TRANS/WP.29/759 20 December 2000

DRAFT 01 SERIES OF AMENDMENTS TO REGULATION No. 96

(Emissions of agricultural and forestry tractors)

Model A

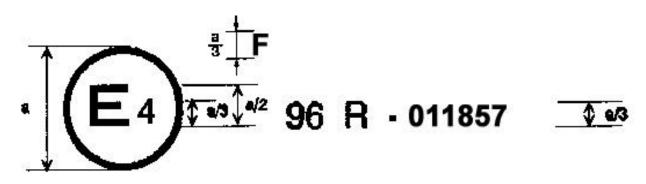
Annex 3, amend to read:

The above approval mark affixed to an engine shows that the engine type concerned has been approved in the Netherlands (E4) pursuant to Regulation No. 96 (according to the level corresponding to power band F) and under approval number 011857. The first two digits of the approval number indicate that Regulation No. 96 was in its amended form (01 series of amendments) when the approval was granted.
